SUBJECT: Forwards reys to FSAR Section 53 re stainless steel weld cladding & fracture toughness. Revs show conformance w/10cfr50 Apps G & H & will be incorporated in next FSAR amend.

SUSQUEHANNA STEAM ELECTRIC STATION
FSAR SECTION 5.3
ER 100508 FILE 841-1
PLA-1847

In order to support obtaining an operating license for Susquehanna SES Unit 2, enclosed are revisions to Section 5.3 of the Susquehanna SES FSAR. These revisions show the conformance of Unit 2 with 10CFR50 Appendices G and H. These revisions will be incorporated in the next amendment to the FSAR.

**MINIMUM TEMPERATURE REQUIRED
vs. REACTOR PRESSURE
SUSQUEHANNA UNIT 2**

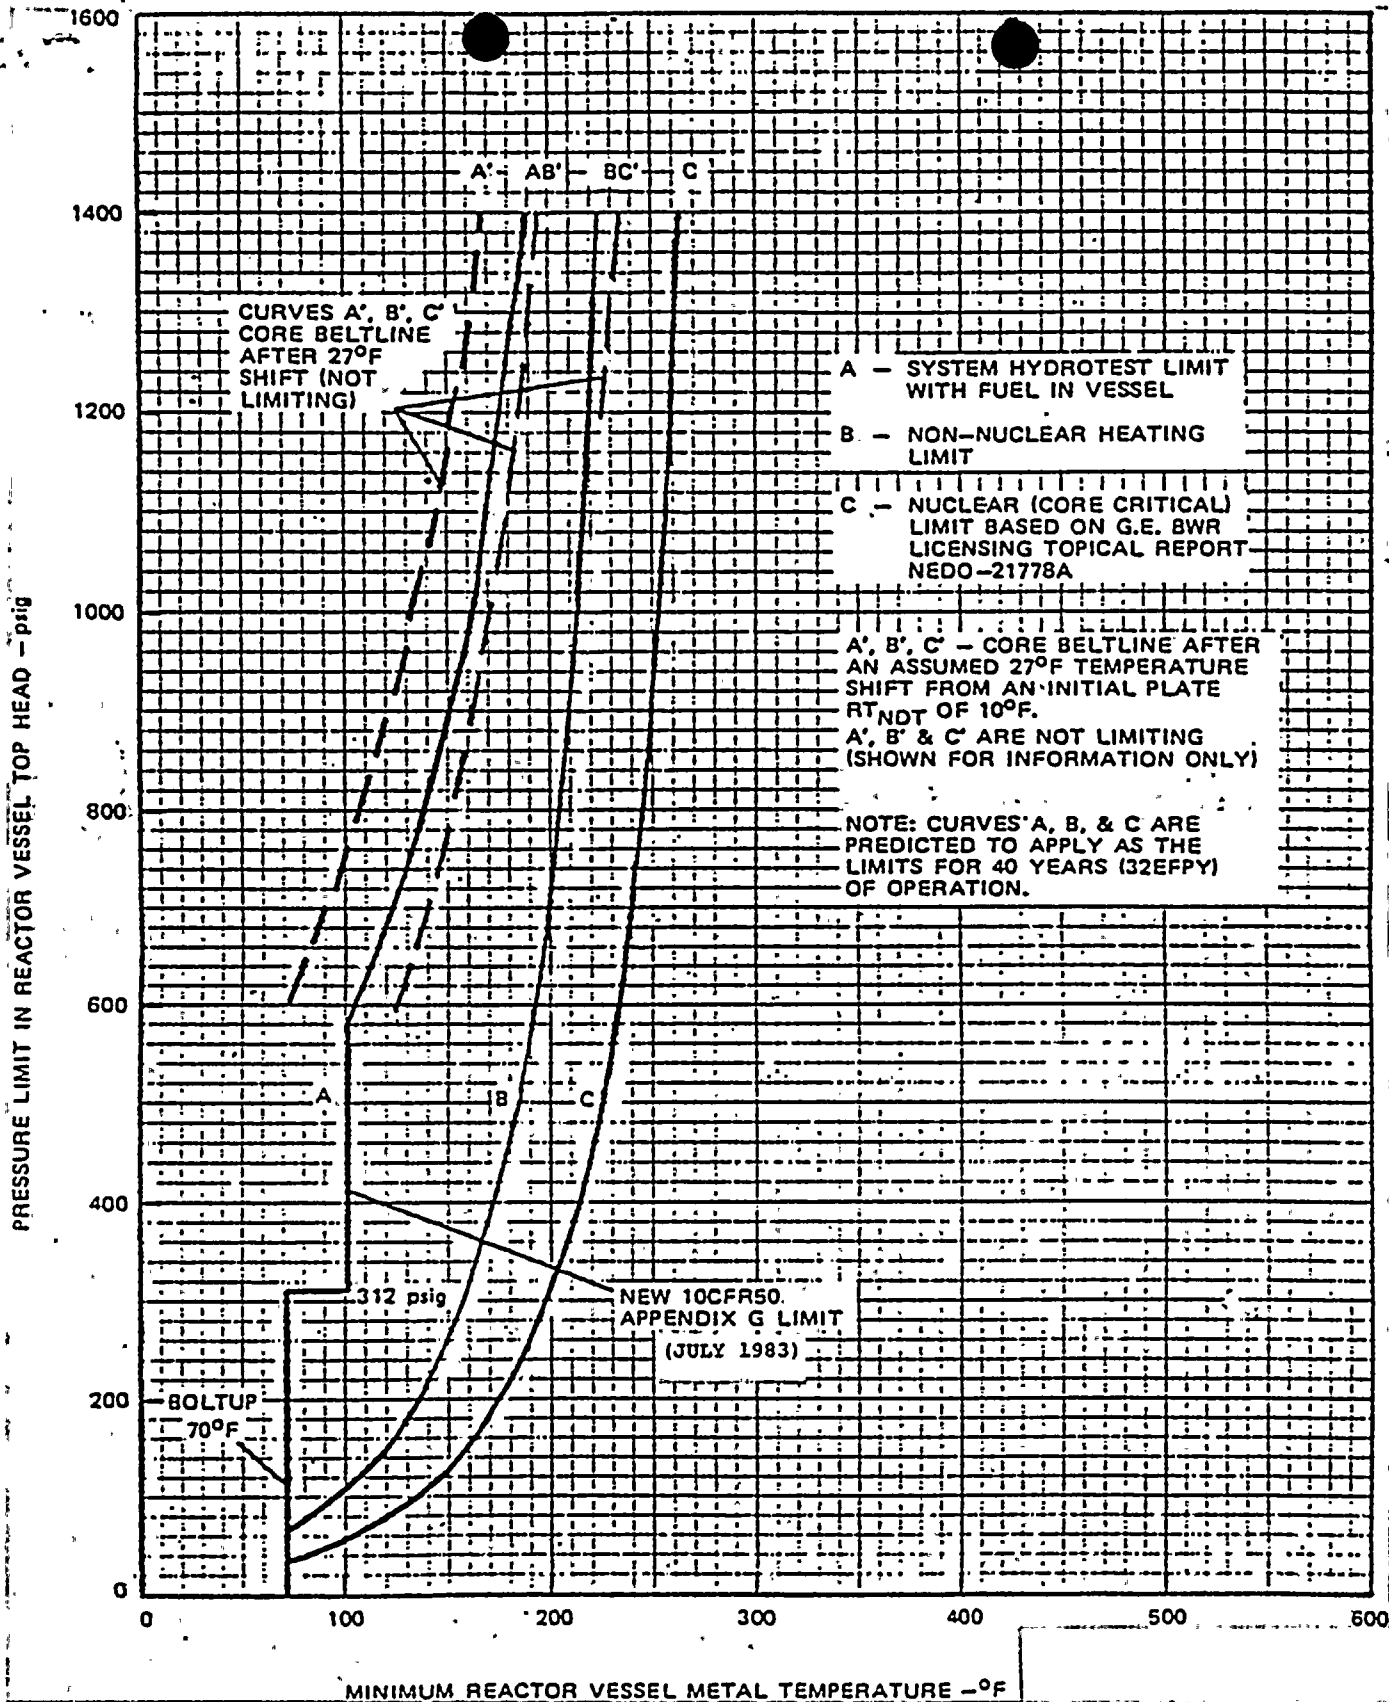
The effect of the main closure discontinuity was considered by adding 60°F to the RT_{NDT} to establish the minimum temperature for boltup and pressurization. The minimum bolt-up temperature of +70°F for Units 1 and 2, which is shown on Figures 5-3.4a and 5.3-4b, is based on an initial RT_{NDT} of +10°F for the closure flange forgings.

The fracture toughness analysis was done for the normal heatup or cooldown rate of 100°F/hour. The temperature gradients and thermal stress effects corresponding to this rate were included. The results of the analyses are a set of operating limits for non-nuclear heatup or cooldown shown as curves labeled B on Figures 5.3-4a and 5.3-4b. Curves labeled C on these figures apply whenever the core is critical.
